OB-8

SCHEMATIC 1679A SHEET 2

OBERHEIM ELECTRONICS, INC.
ENGINEERING CHANGE ORDER

ECO NO
406

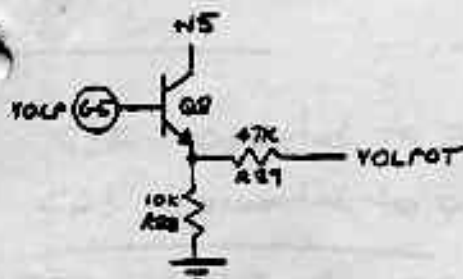
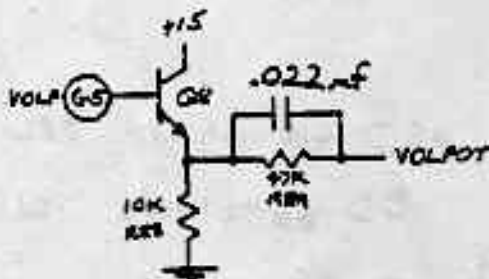
ADD .022 μ F CAPACITOR IN PARALLEL WITH R89.

TO ELIMINATE NOISE WHEN CONTROLLING THE VOLUME'S WITH AN EXTERNAL LOW IMPEDANCE VOLTAGE SOURCE.

OB-8 POT. Board 1&2 1681A

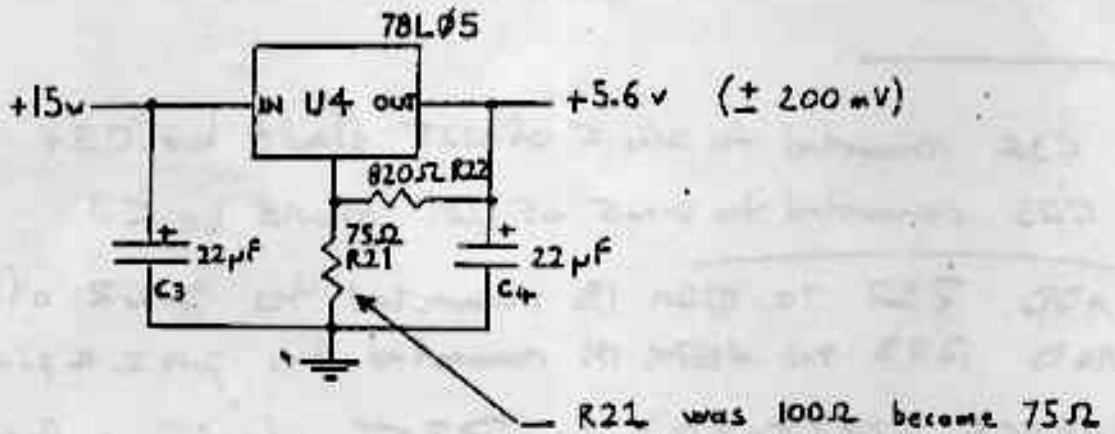
Reduce output of 5.6v Supply.

Increase the active range of the Front panel pots

OB-8 VOICE BOARD 1682A

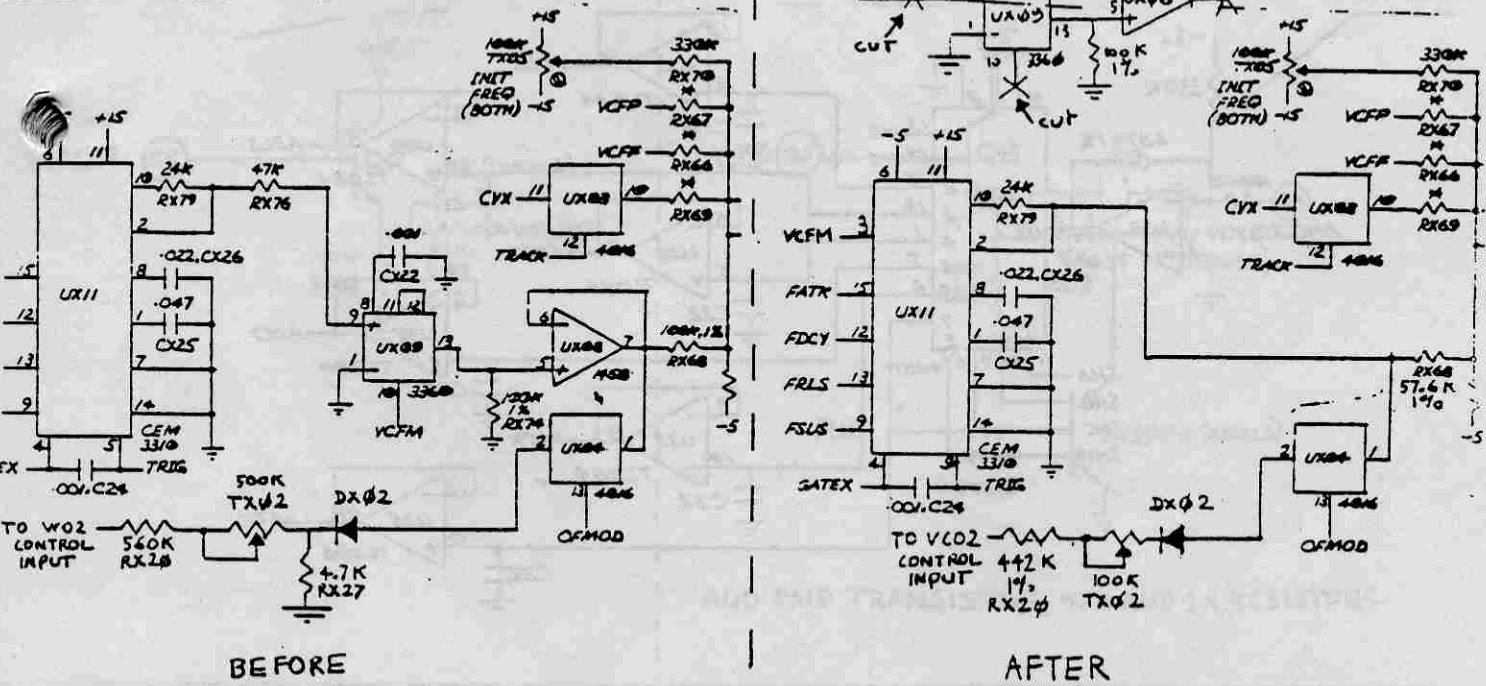
The 336 ϕ VCA is bypassed and the 331 ϕ in conjunction with the software modulates the amplitude of the envelope. A software revision A-4 or posterior must be installed.

331, at the output of U27 is short circuited. ~~R30~~ is removed (see sheet 2)

Improve temperature stability and tracking of VCO2 filter env. modulation

OB-8 VOKE BOARD 1682A

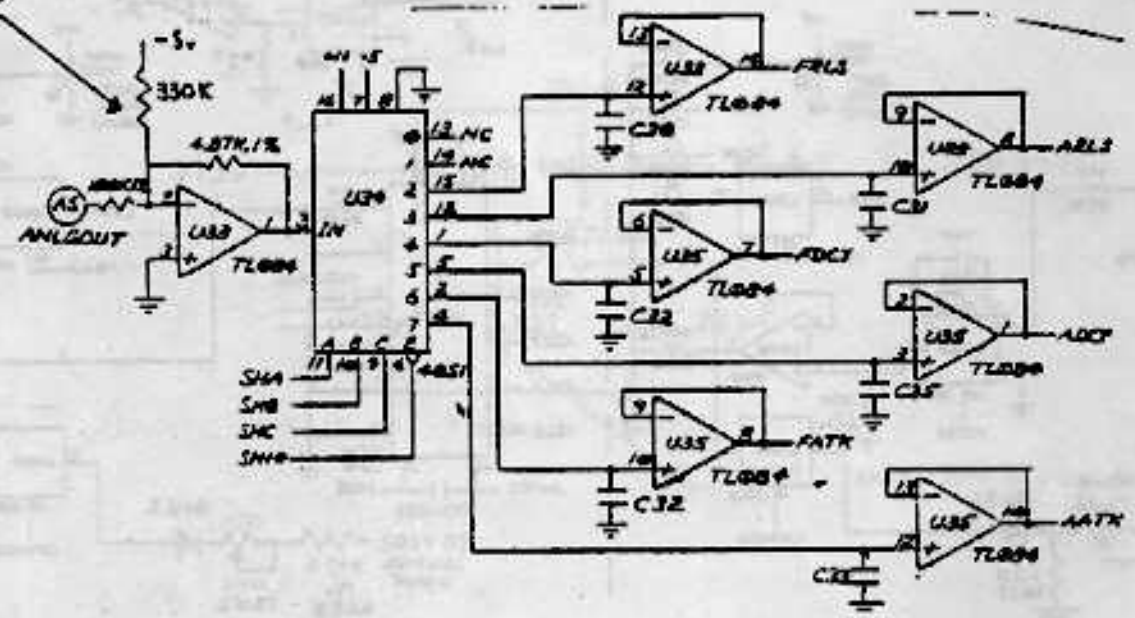
Add a resistor between -5v and pin 2 of U33 (upper & lower voice)
A software revision A-4 or posterior must be installed and the offset
calibration of the service center test must be performed.

The offset calibration routine of the service center test can correct
the TL084 For positive or negative offset.

SCHEMATIC 1679 A, SHEET 2
OB-8 PROCESSOR BOARD

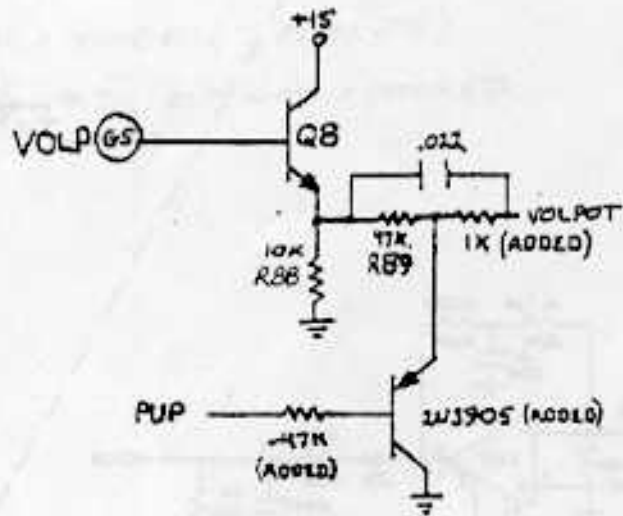
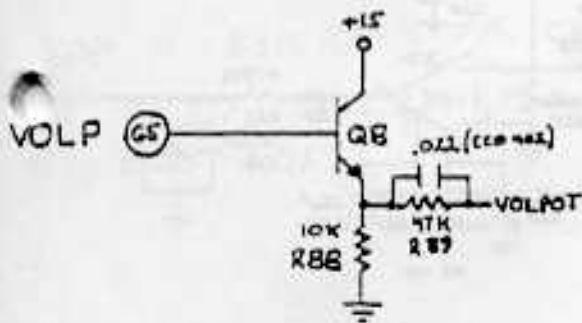
ADD PNP TRANSISTOR, 47K AND 1K RESISTORS

TO REDUCE POWER-DOWN GLITCH AT OUTPUTS

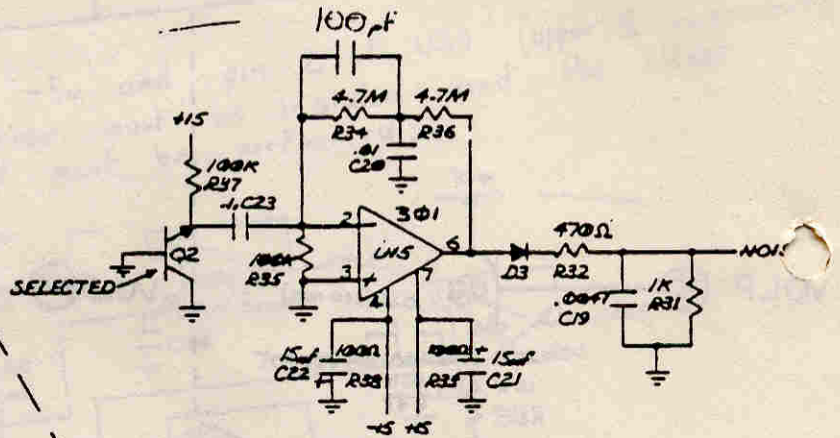
ADD A 100pF CAPACITOR
IN PARALLEL WITH R34

ON REVISION A PROCESSOR BOARDS, WHEN A SEQUENCER IS CONNECTED,
DISTORTION BECOMES PRESENT IN THE NOISE GENERATOR.

OB-8 BEND BOX 1680A SHEET 1 OF 1

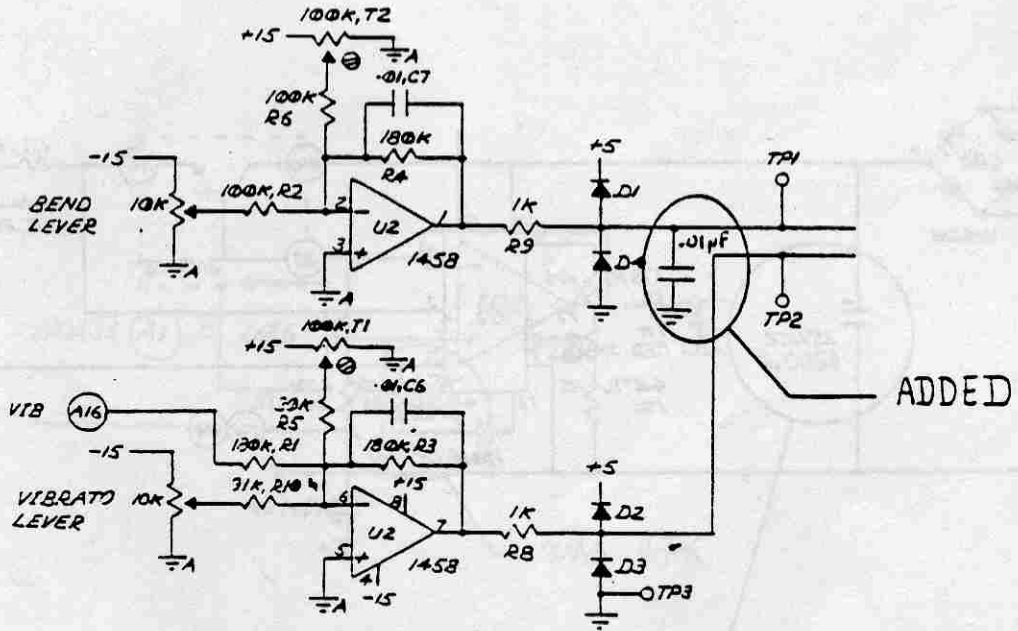
- REMOVES NOISE MODULATION FROM BENDER LEVER

PROCESSOR BOARD- POWER SUPPLY
1679A SHEET 4 of 4

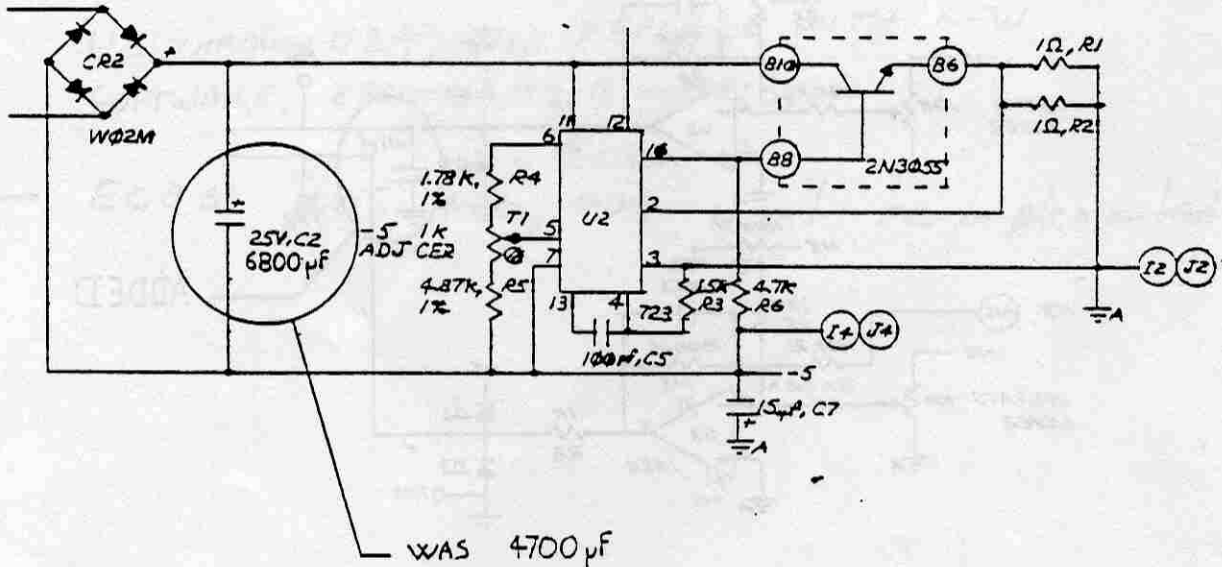
(REFERENCE ECO # 401)

WHEN THE NEW POWER SUPPLY TRANSFORMER (REF. 561021) IS USED, THIS CHANGE DECREASES THE OUTPUT THUMP ON POWER OFF.

VOICE BOARD 1682A SHEET 2 OF 3

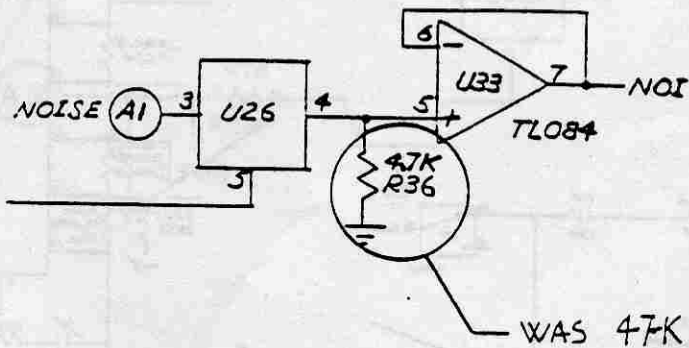
REMOVE LEAK OF NOISE GENERATOR WHEN A VOICE IS GATED

1682A VOICE BOARD

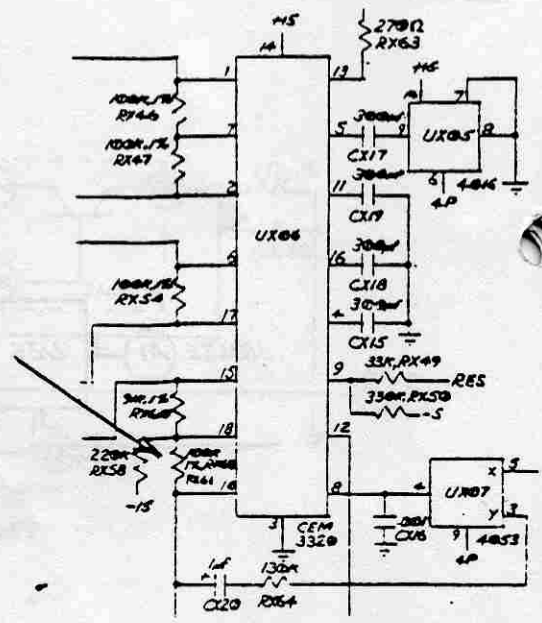
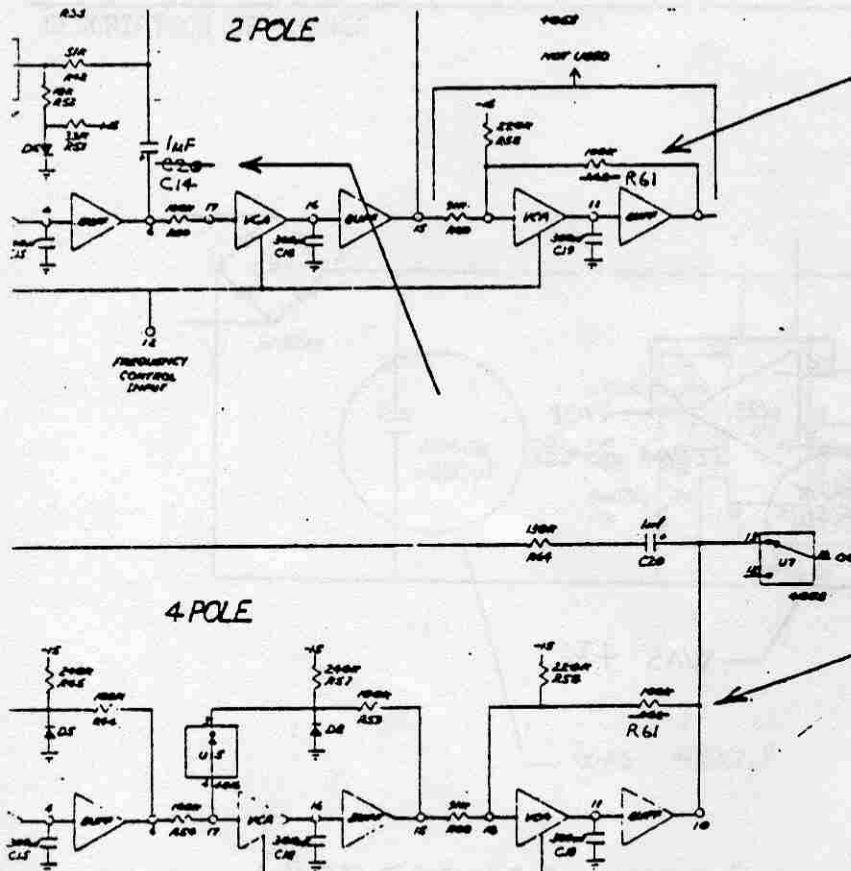
RESISTOR AT UX06 PINS 10, 18 MARKED RX68 SHOULD BE RX61.
 CAPACITOR IN 2 POLE/4 POLE CONFIGURATION DRAWING MARKED C20 SHOULD BE C14.

1682 B OB-8 VOICE BOARD (UPPER)

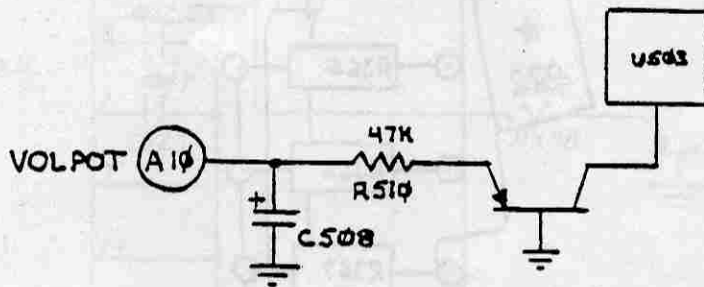
Change C508 from 0.1uf Mylar To 2.2 Electrolytic (Upper Voice only)

To eliminate noise at output at low master volume levels

1632 B OB-8 Voice Board
1689 B

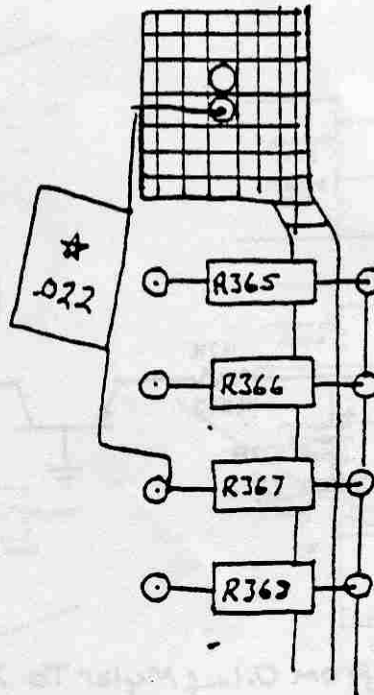
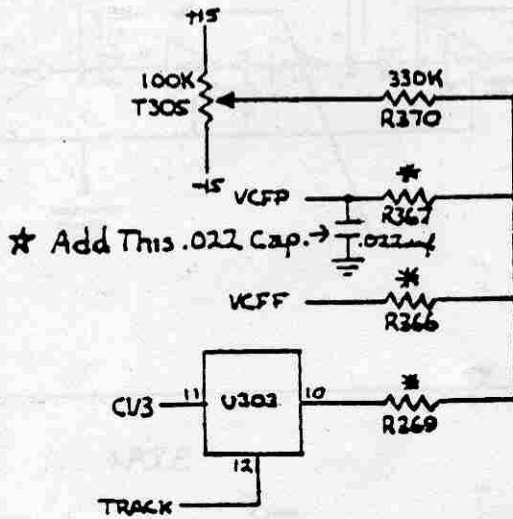
Add a .022 Mylar Capacitor To both The Top and bottom Voice Boards

To Filter-out digital noise picked up along The Filter Pedal line (VCFF) when a Sequencer (05X) is connected.

OB-8 VOICE BOARD 16.82 B SHEET 3 OF 3

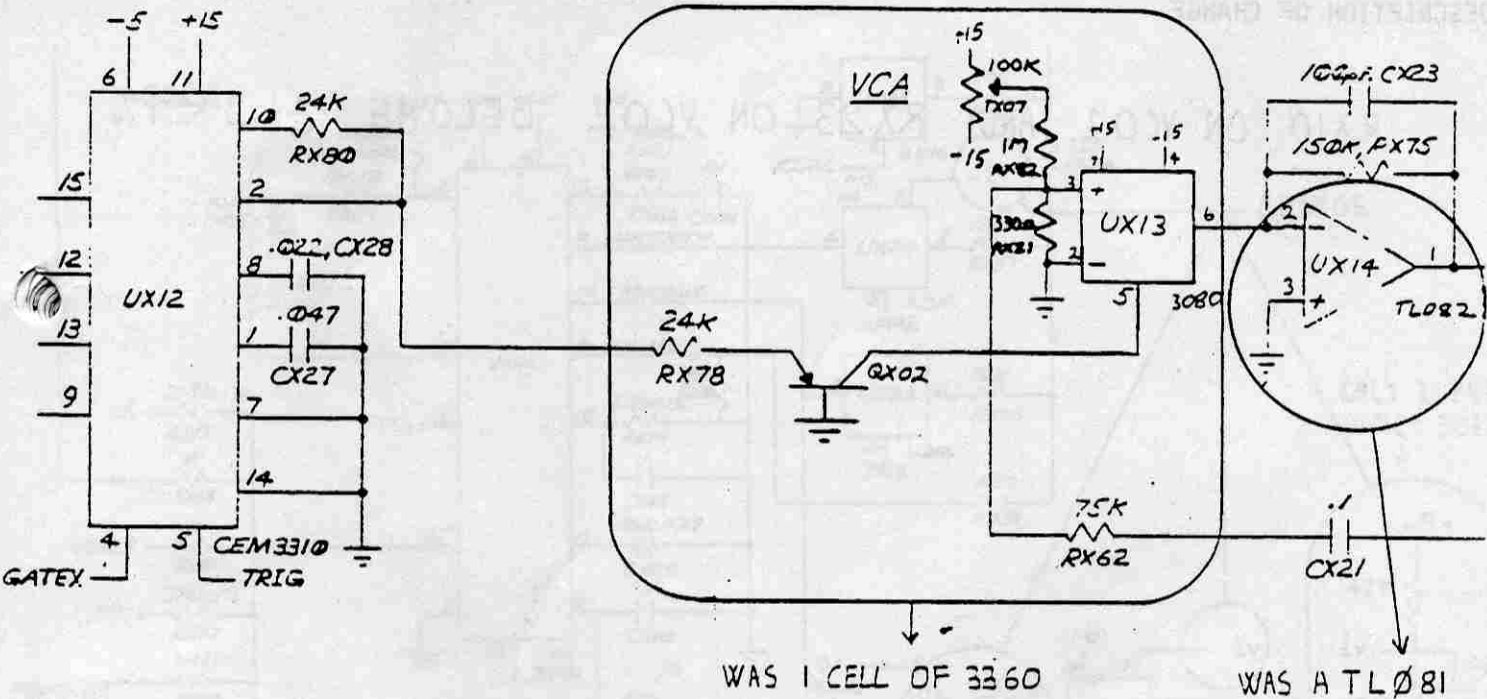
- ALSO: UX08 IS DELETED AND REPLACED BY THE OTHER CELL OF THE TL082 UX14

- RATIONALIZE THE CIRCUITRY

OB-8 VOICE BOARD 1682A SHEET 3 OF 3

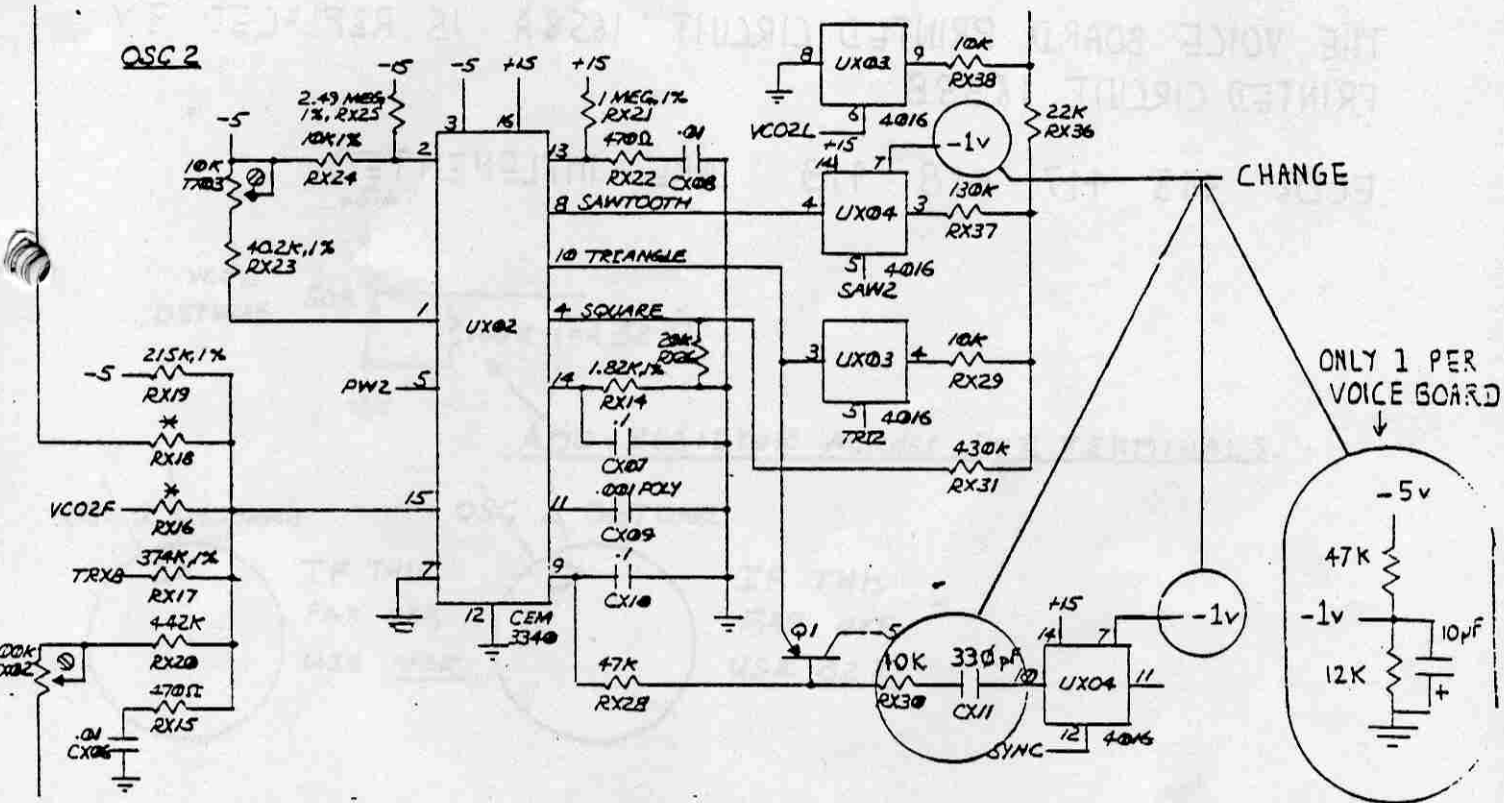
- IMPROVES SYNCHRO SOUND

POT BOARD 1681 B

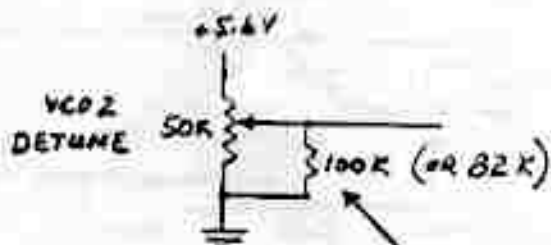
ADD RESISTOR ACROSS POT. TERMINALS.

IF THIS
FAR OFF,
USE 100K

IF THIS
FAR OFF,
USE 82K

TO CENTER OSC 2 DETUNE CONTROL WHEN LED GOES OFF
WITH KNOR SIGNIFICANTLY COUNTERCLOCKWISE OF CENTER.

OB-8 VOICE BOARD 1682B SHEET 2

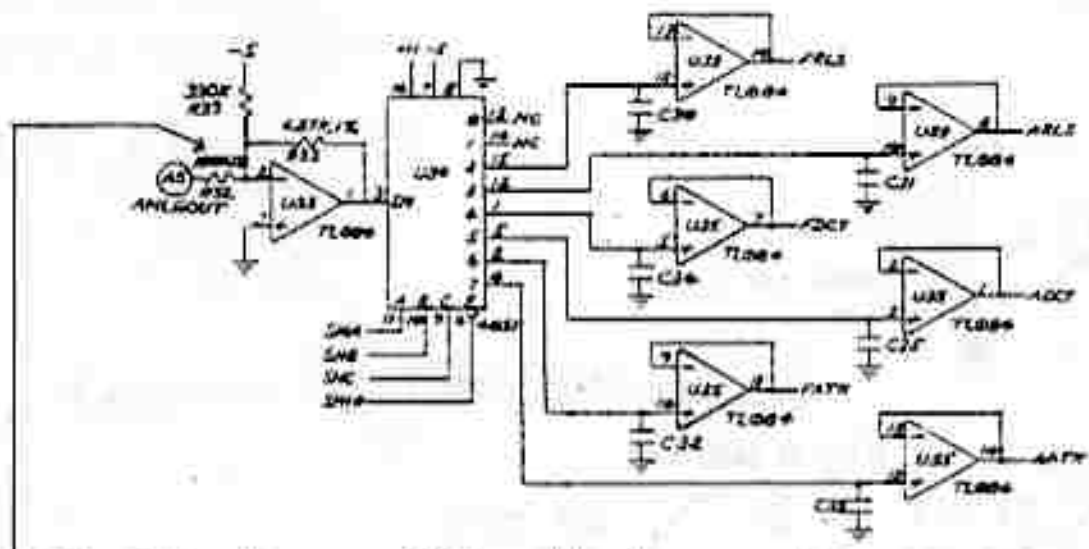
R32 100K 1% are 50Ω matched between Lower and upper Tray.

R32 on the Lower and upper tray are mounted after the two boards are screwed together.

— IMPROVES MATCHING OF TIMING BETWEEN ENVELOPES OF UPPER, AND LOWER TRAY.

1679 B - SHEET 1

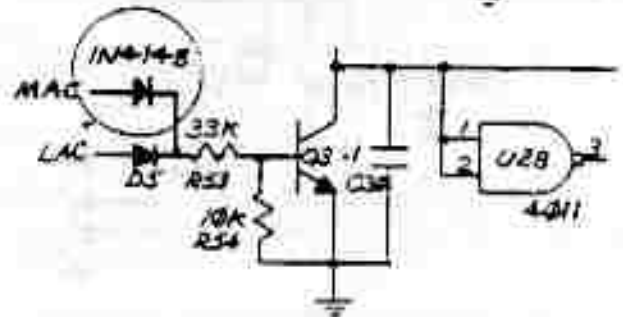
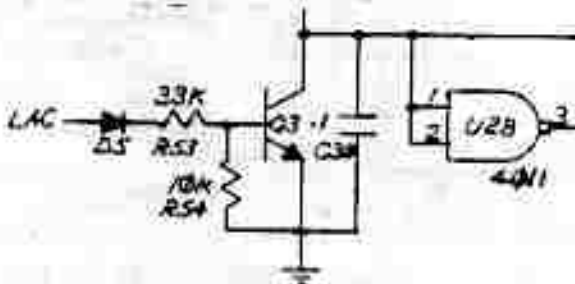
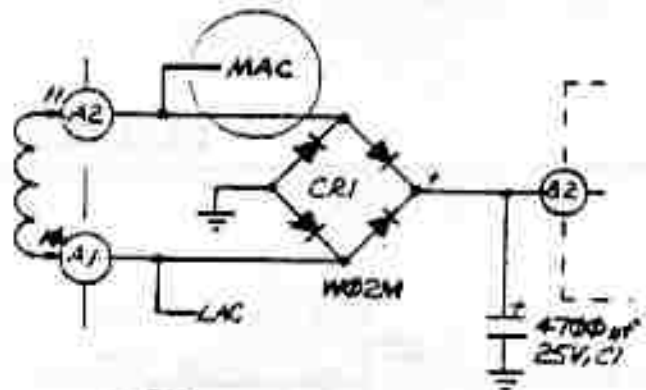
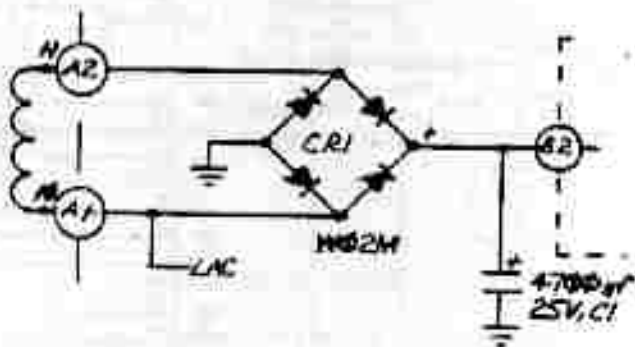
IMPROVE MARGIN OF "PUP" CIRCUIT TO INADVERTENT TURN-OFF, ESPECIALLY AT 50 KHz.
